The history of revision change for the specification

Power Choke Coil VCHA105D MS6 type

■ Recommend Land Pattern Dimensions

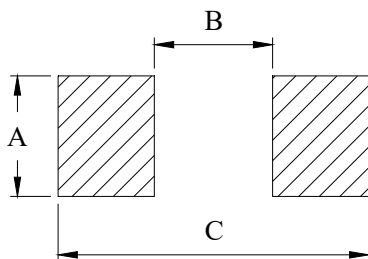
Document	REV.	Modified date	Description
CYNVC-175-018	A0	2017.5.31	New Approval
CYNVC-175-018	A1	2017.6.19	1. May -> Jun. 2. Remove spec of 101 3. Remove curve of 101 4. Add spec of 120
CYNVC-175-018	A2	2017.11.13	1. Add curve of 120 2. Jun. -> Nov.
CYNVC-175-018	A3	2018.3.13	1. Add "AEC-Q200" logo on page 2 2. Nov., 2017 -> Mar., 2018 3. Year code 2017 = 7 -> 2018 = 8
CYNVC-175-018	A4	2018.6.15	1. Mar. -> Jun. 2. Add spec of R22 3. Add curve of R22
CYNVC-175-018	A5	2018.11.13	1. Jun. -> Nov. 2. Remove spec & curve of R22, 120
CYNVC-175-018	A6	2019.9.16	1. Nov., 2018 -> Sep., 2019 2. Add spec & curve of 101
CYNVC-175-018	A7	2020.1.21	1. Sep., 2019 -> Jan., 2020 2. Year code 2019 = 9 -> 2020 = 0
CYNVC-175-018	A8	2020.6.15	1. Jan. -> Jun. 2. Add spec and curve of R68 3. Add rated voltage
CYNVC-175-018	A9	2020.9.9	1. Jun. -> Sep. 2. Update Land Pattern A: 4.95 -> 5.0 ; B: 5.4 -> 4.9 ; C: 13.6 -> 12.88

A	5.00
B	4.90
C	12.88
